ADDENDUM NUMBER: One (1)

DATE: November 12, 2025

PROJECT: MONTGOMERY COUNTY EMS STATION 28

DESIGNER: DOUGLAS A. JONES, ARCHITECT
MONTGOMERY COUNTY ENGINEERING

C8.4

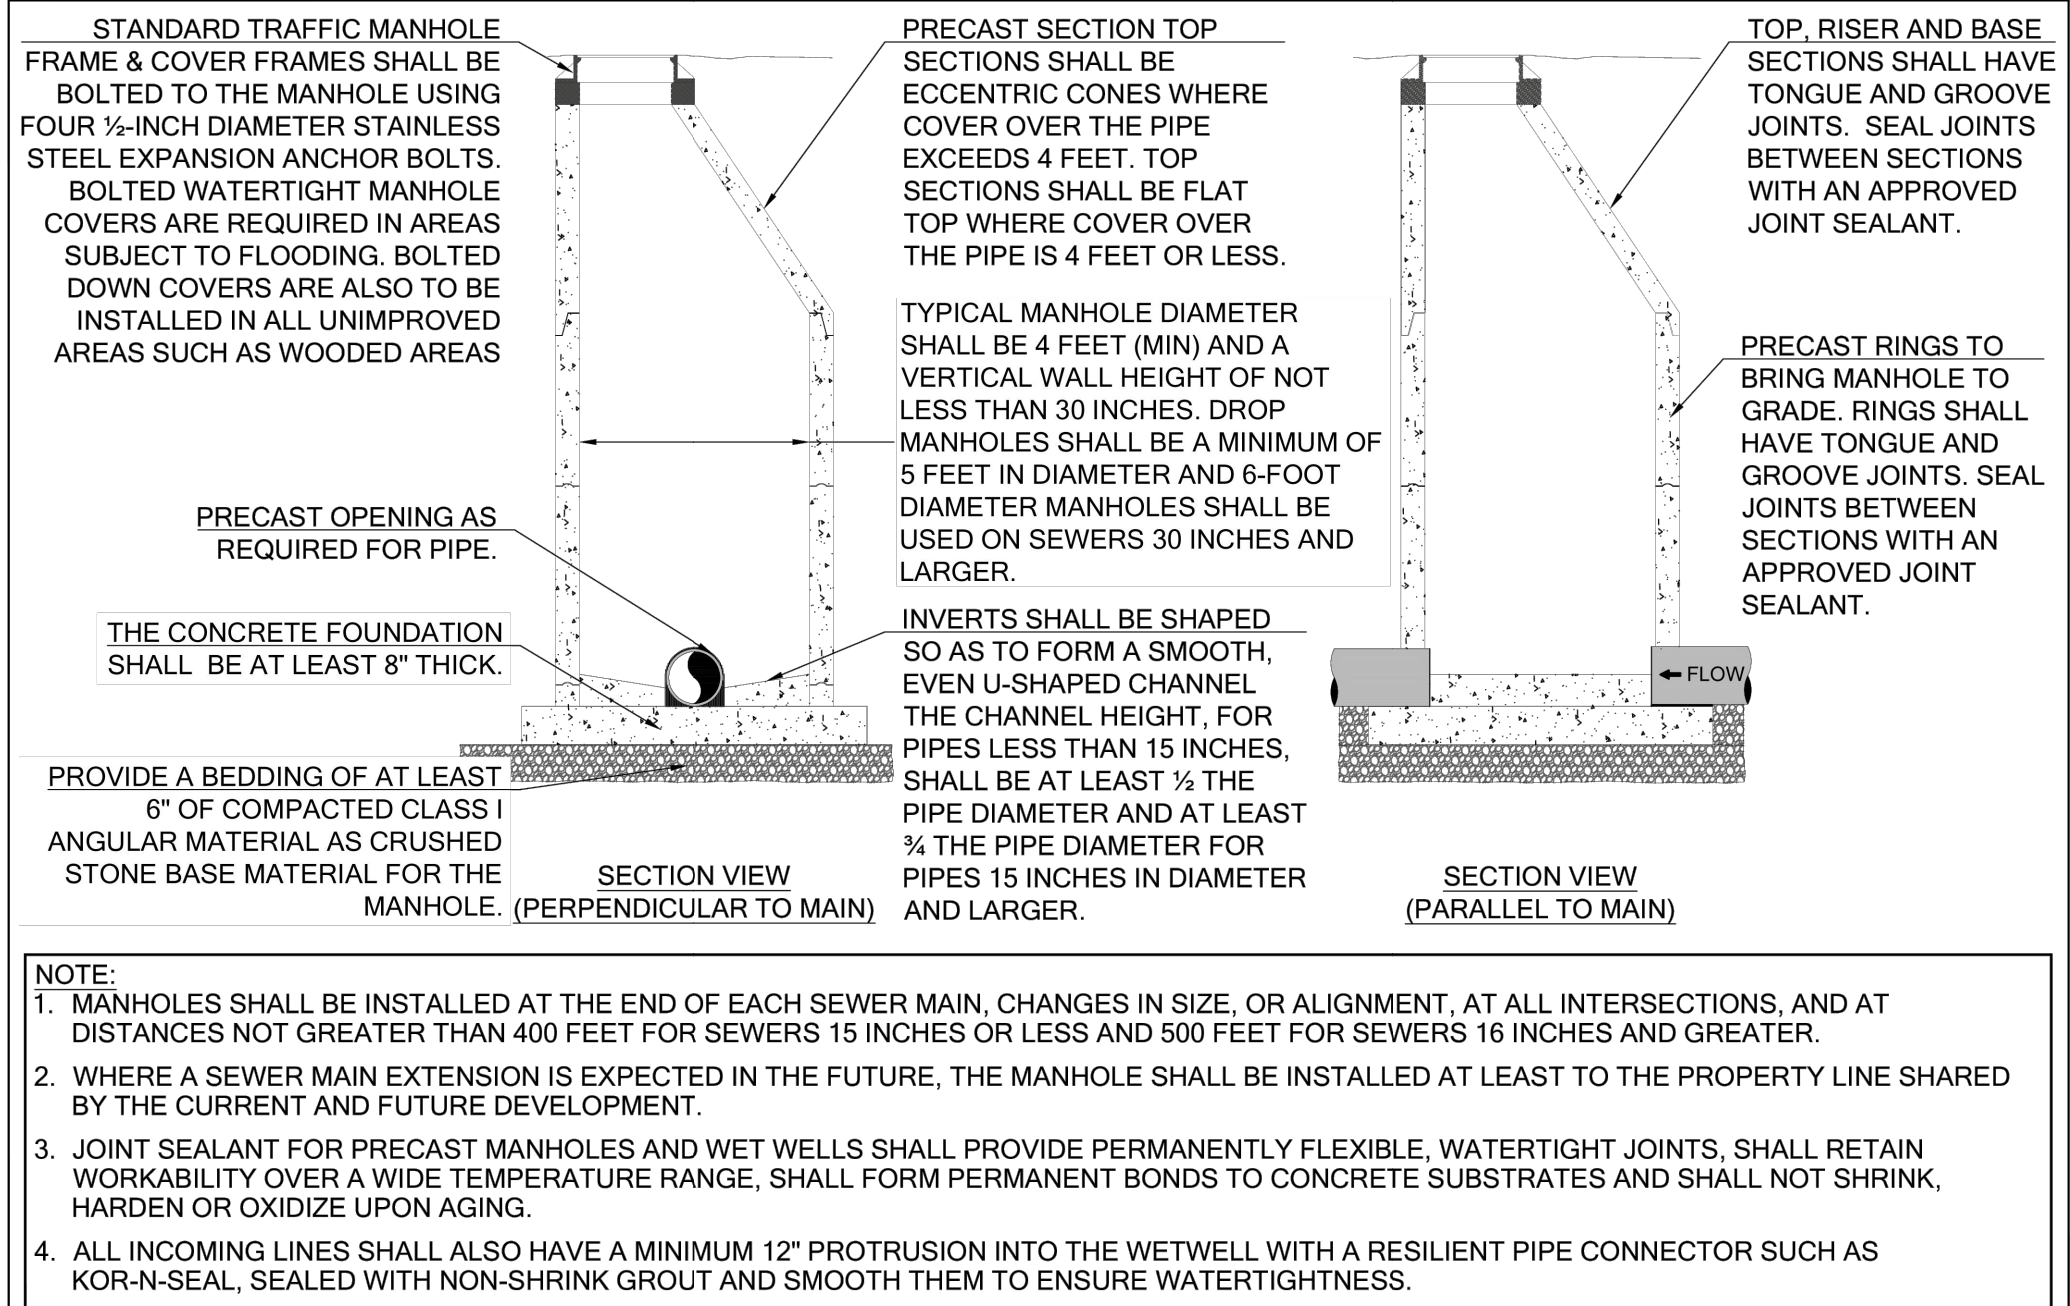
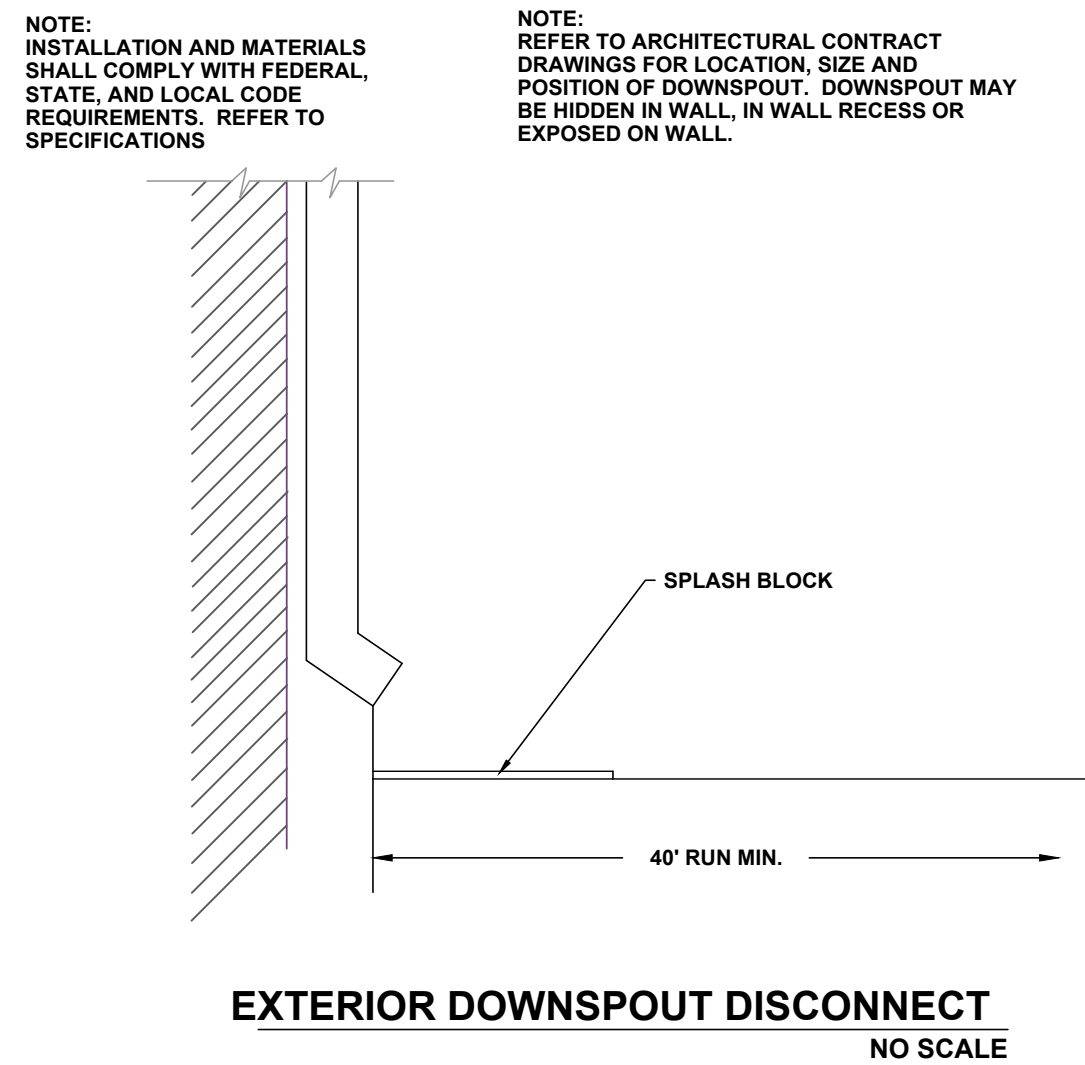
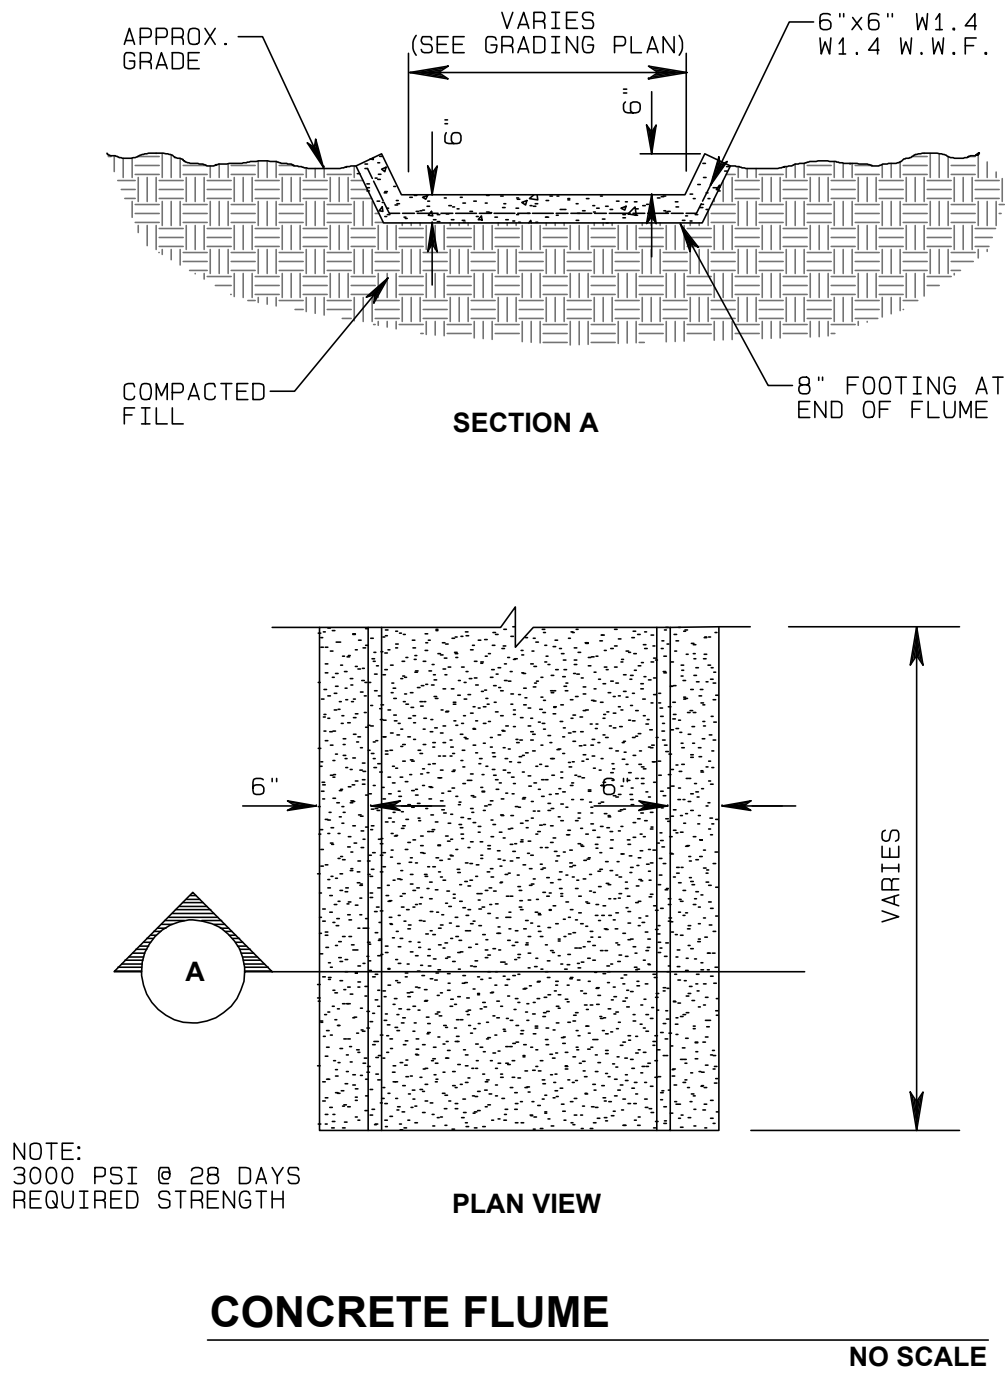
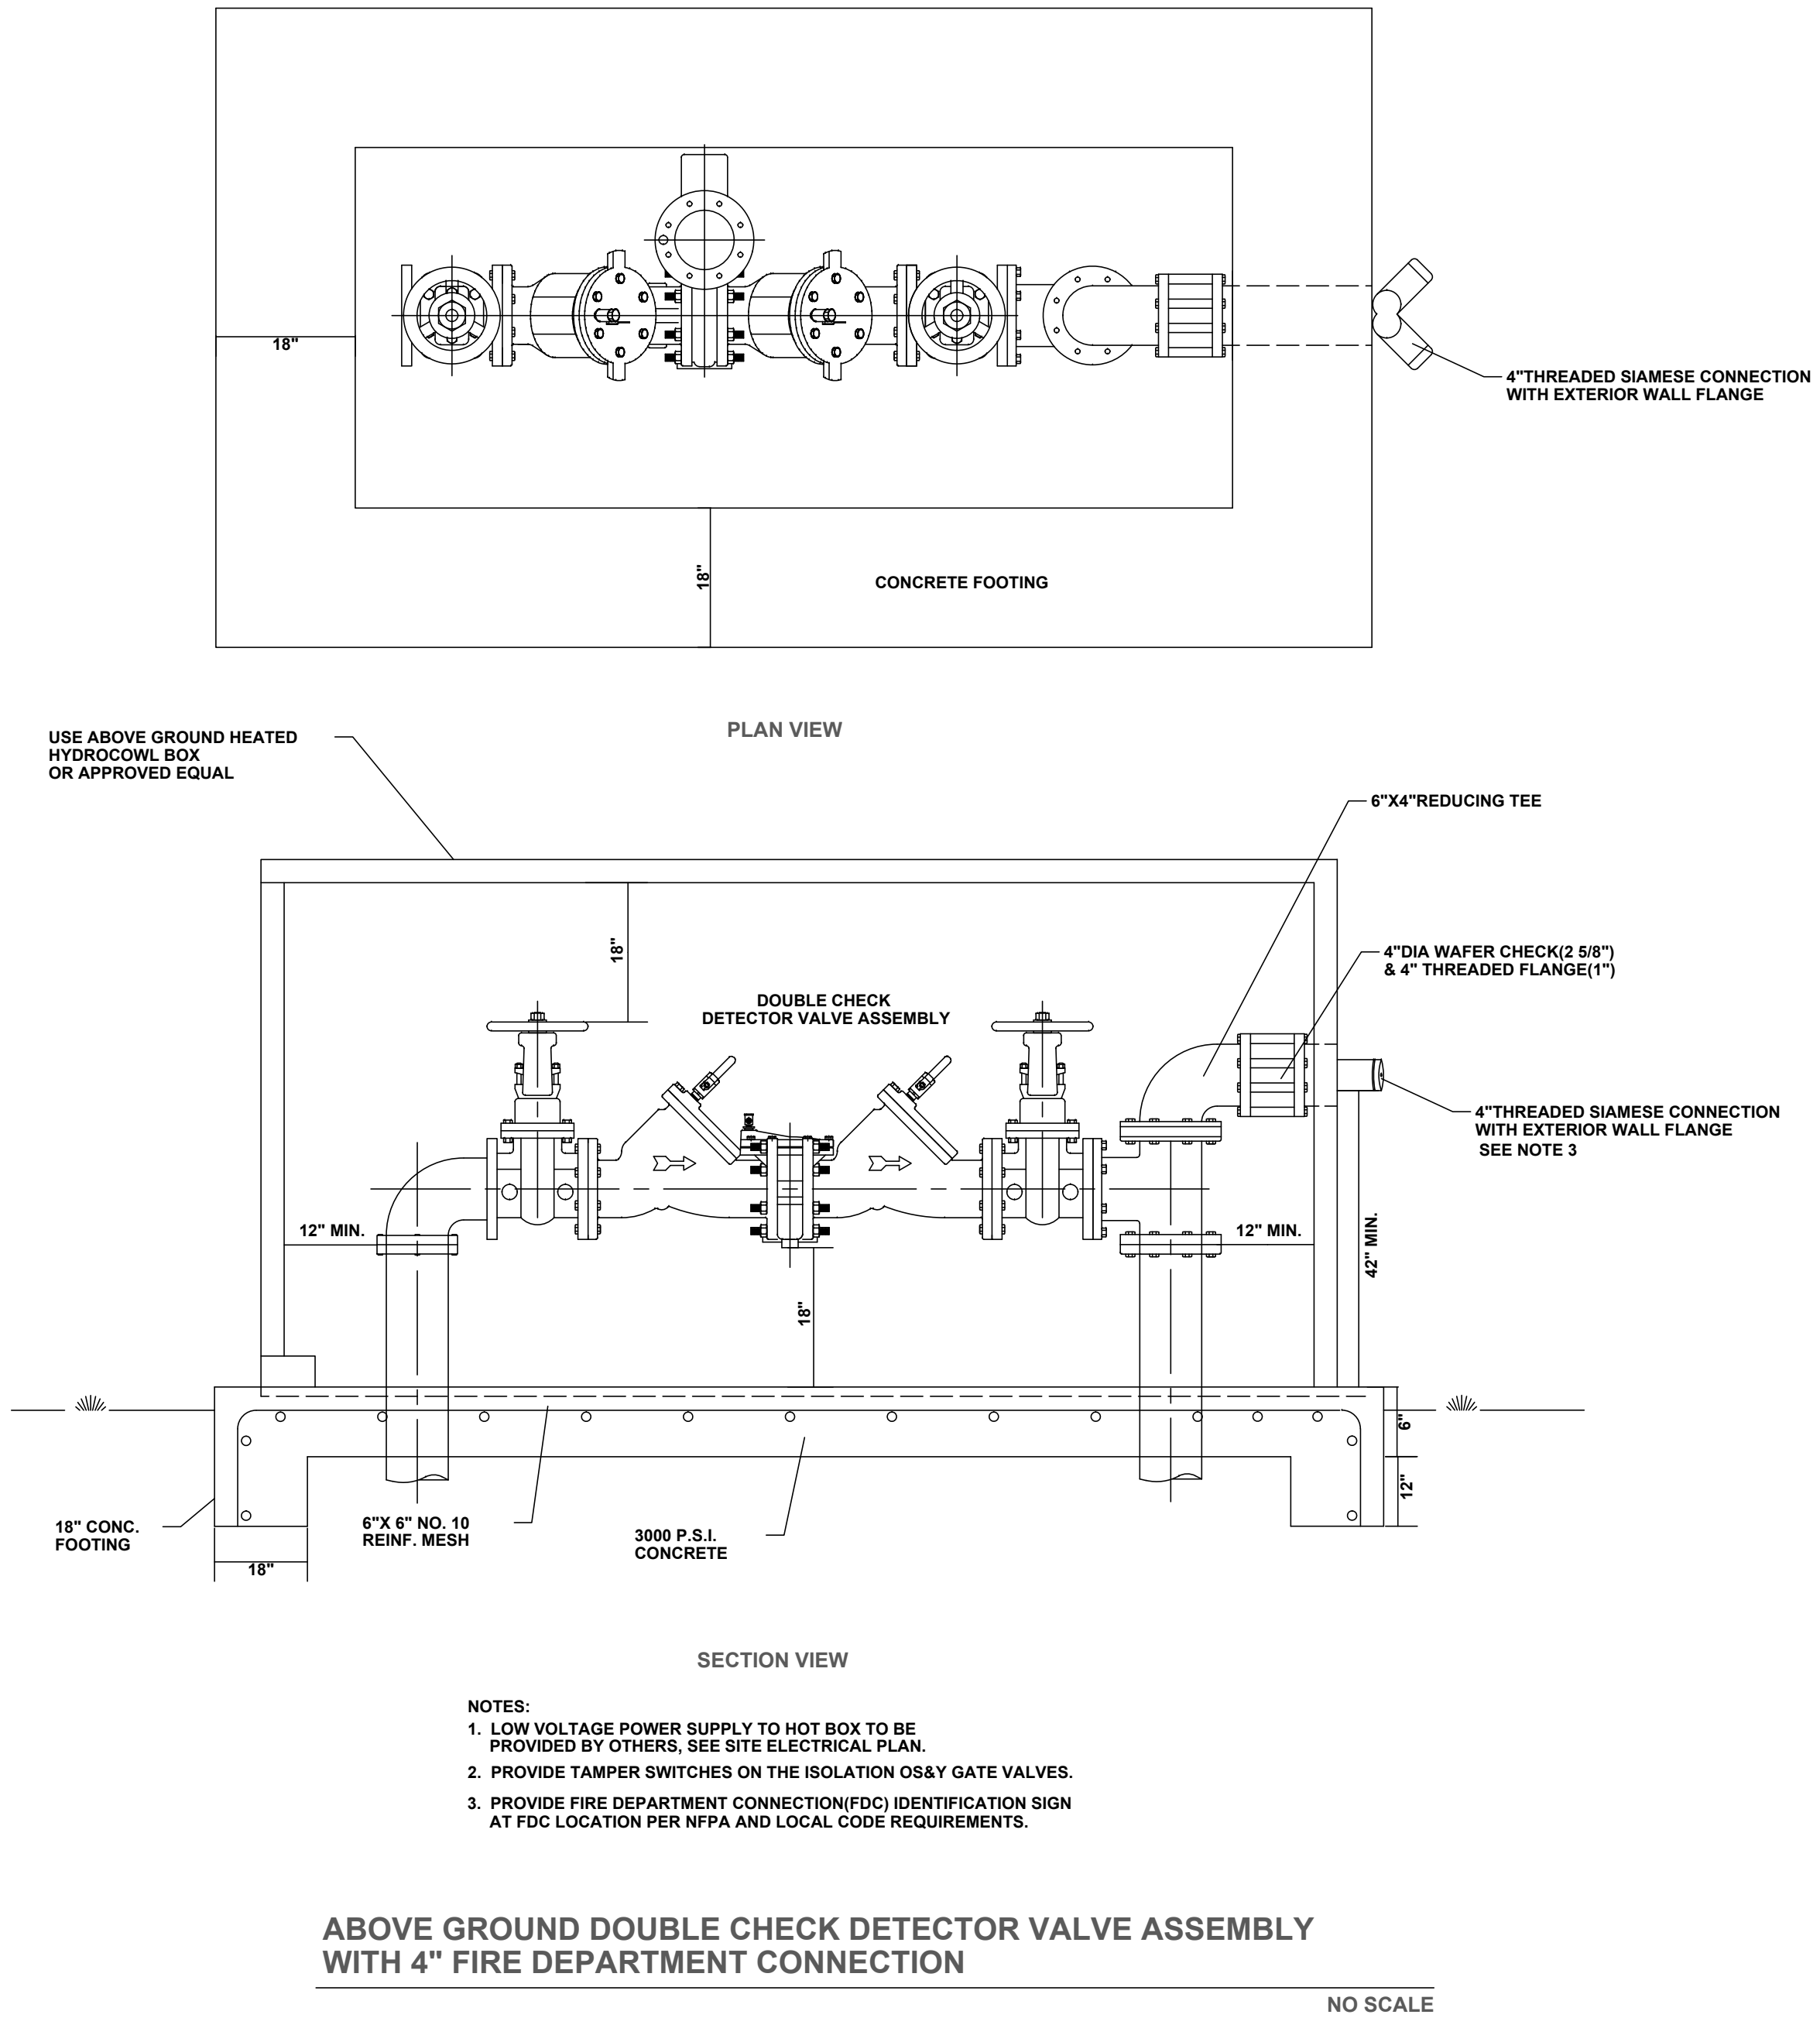
SHEET C8.4 - GENERAL SITE DETAILS; Delete Sheet C8.4 dated 11/03/2025 in its entirety. Substitute therefor: Sheet C8.4 - GENERAL SITE DETAILS dated 11/12/2025 attached hereto.

Clarification: Manhole Detail was added.
